To: MICE Spectrometer Review Committee File

Subject: Recommendation on vacuum system for MICE magnet email

Figure 2. Heat flux through MLI systems near 20K

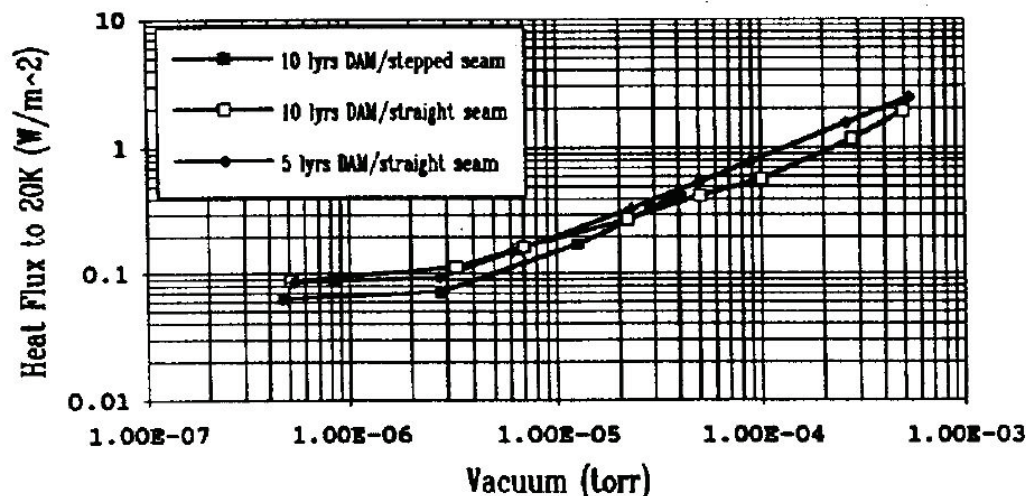
Best practices for a vacuum space of this size would indicate a pump out port of a minimum of 4" and up to 6" pumped out with a 150-200 L/s turbo. The large volume of MLI used in this magnet also points to the need for much greater pump capacity. Vacuum instrumentation should include a device that can monitor the vacuum at all times, i.e., below that which a thermocouple gauge is sensitive. A vacuum of  $10^{-5}$  T assumes good performance. However, a vacuum better than  $10^{-3}$  and greater than  $10^{-5}$  does not guarantee the necessary performance as can be seen from the figure given below (from Boroski et al., FERMILAB Conf-92/96).

A large pump port should be added to the magnet. It should have a gate valve so that the pumping system can be isolated and a 150-200 L/sec turbo pump should be used. Any auxiliary pumping ports should have isolation valves between the pump and the tank. Vacuum instrumentation such as a cold-cathode gauge should be added so that the vacuum can be monitored during the entire cooldown procedure.
